**ARCHITECTURAL REVIEW BOARD  
MUNICIPAL PLANNING COMMISSION  
-AGENDA-  
Thursday, June 25, 2026 at 7:00 P.M.**

SUBJECT: Staff Memo for the Meeting of June 25, 2026

**1. Rezoning – PUD Preliminary Plan – 445 E. Granville Rd. (Elford Development/ Boundless)  
PUD 01-2026**

**Sheet Title**  
**South Property Line Planting Plan**

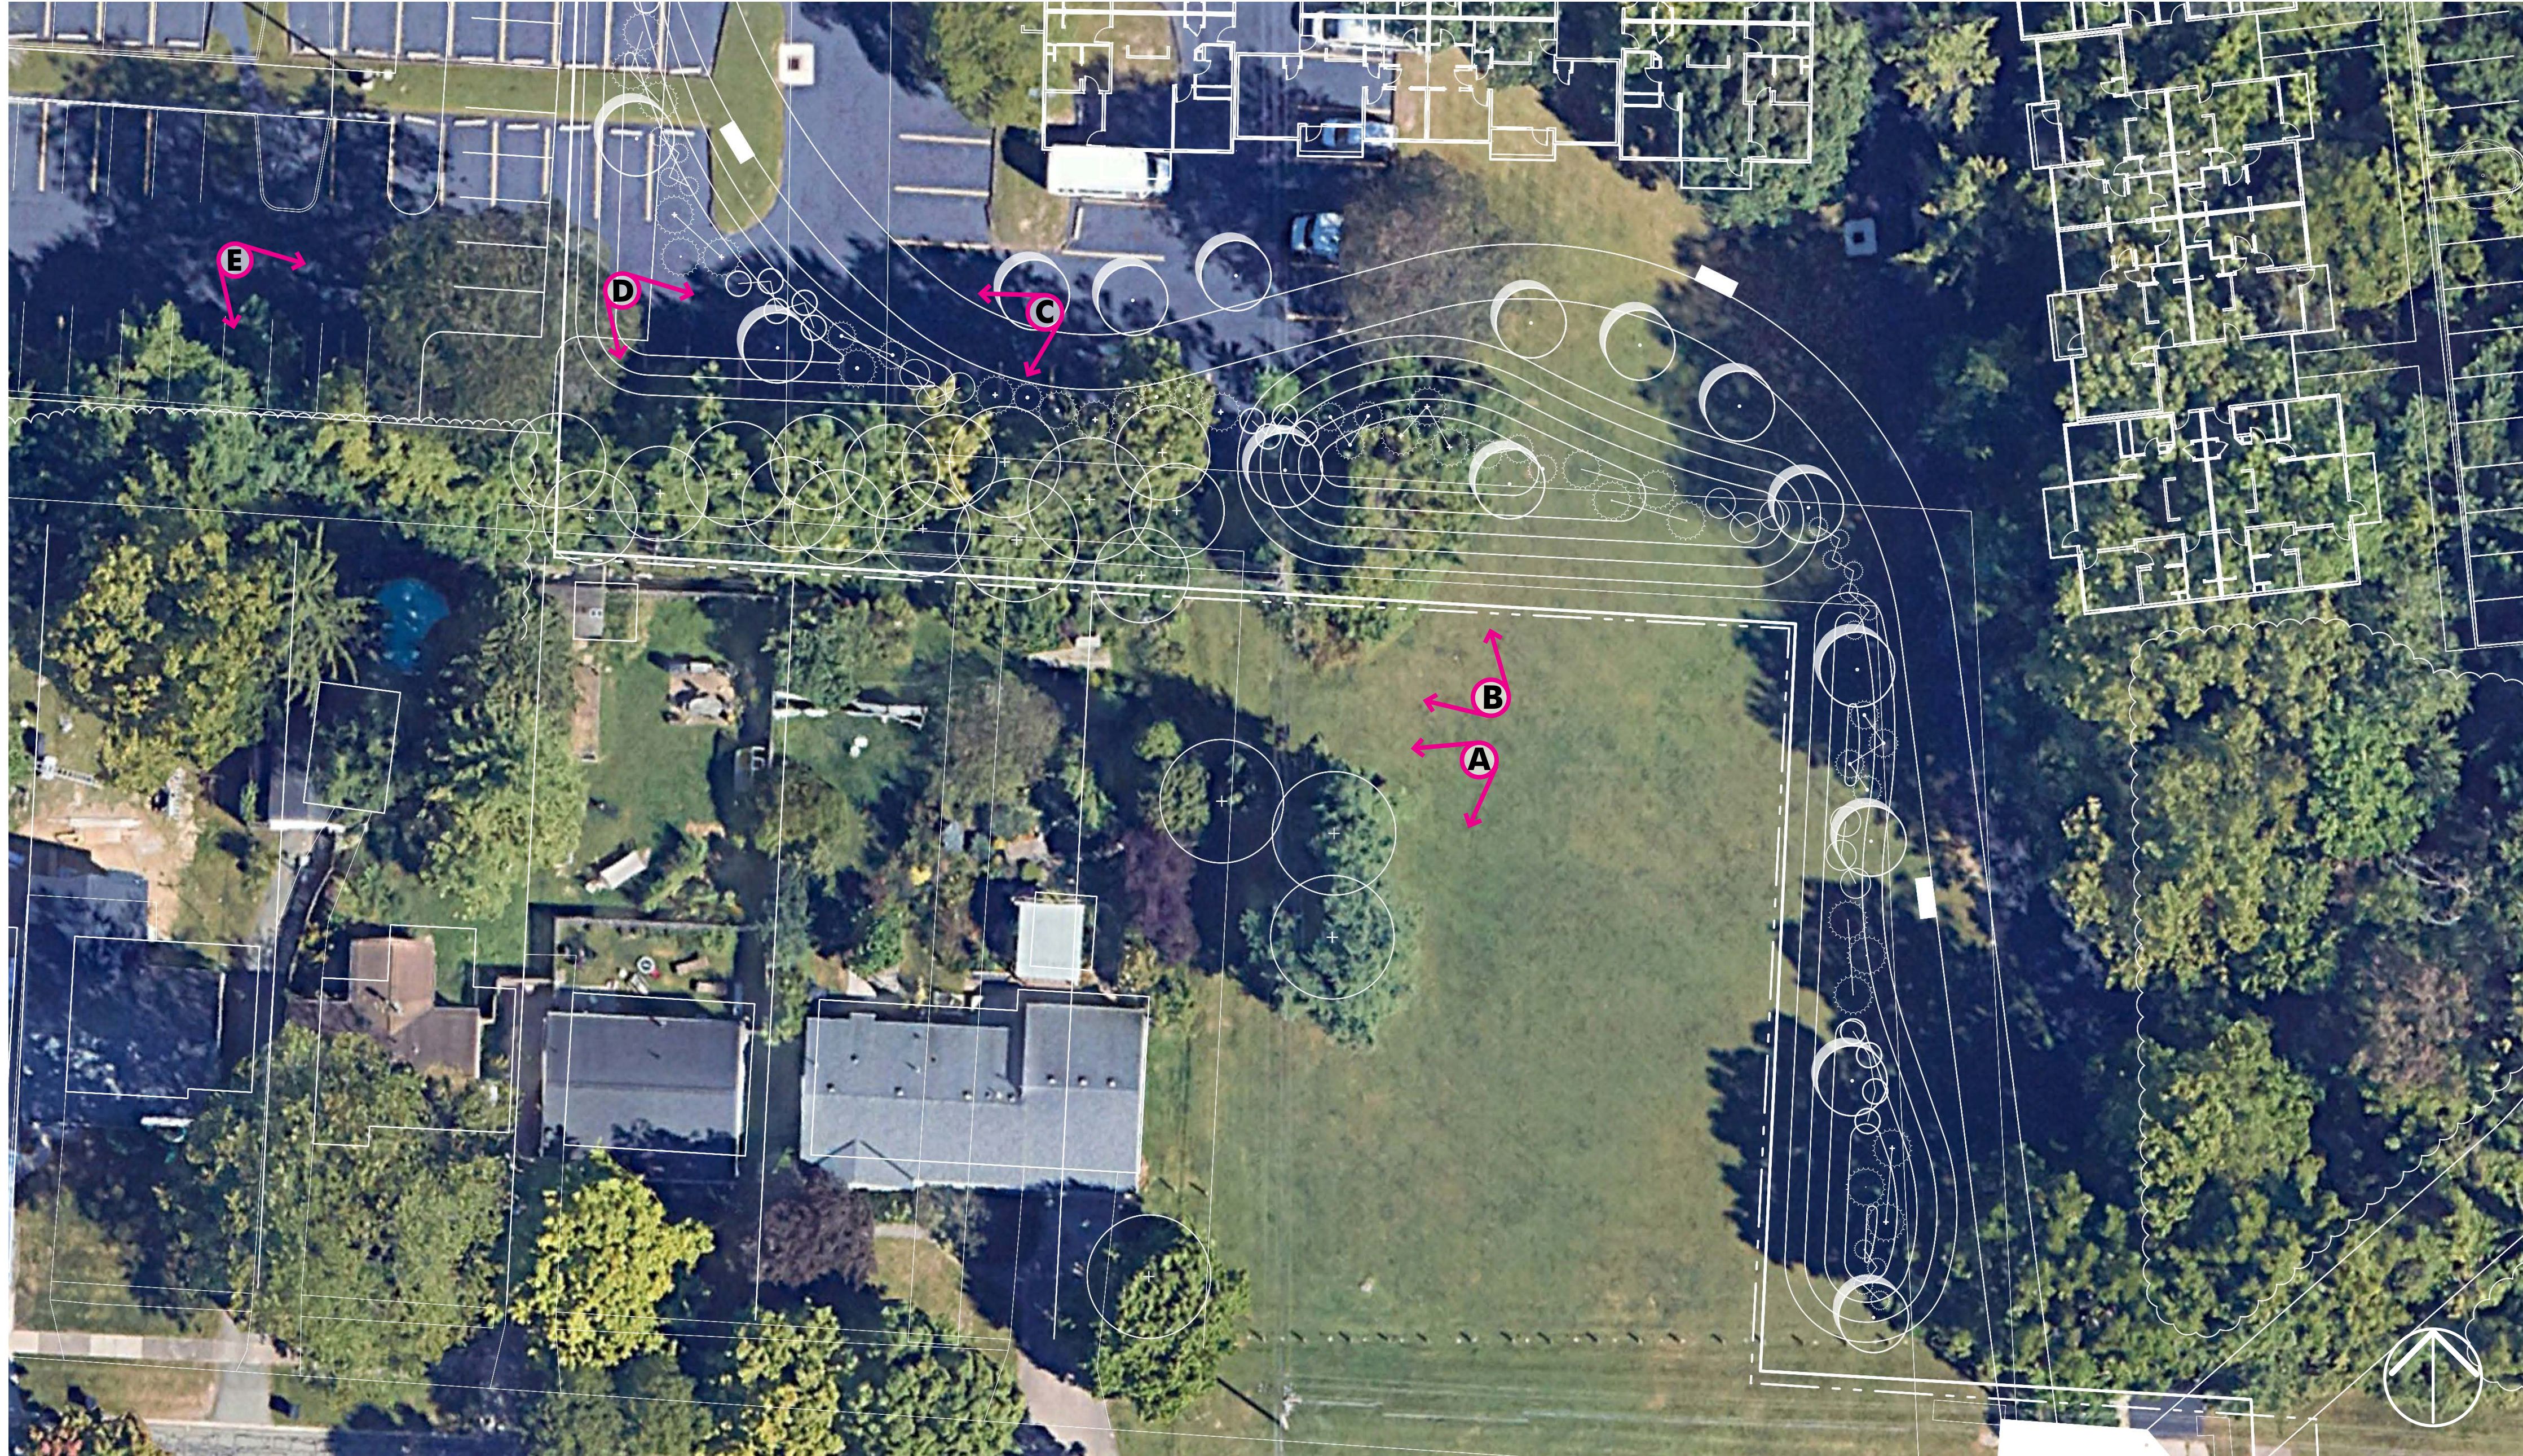
- 1) Tree replacement plan included showing trees in the parking lot and around the site
- 2) Detailed landscaping plan needed with Final Plan
- 3) L2.1 – South Property Line Planting Plan included
  - Mounding shown
  - New deciduous and evergreen trees and shrubs planned
  - Leave healthy trees
  - Remove existing invasive plants
  - Typical foundation plantings shown

- The addition of two single-family lots on Park Overlook Dr. should also help reduce the impact of the development.
  - L2.1 – South Property Line Planting Plan would add additional screening of the site from Park Overlook Dr.
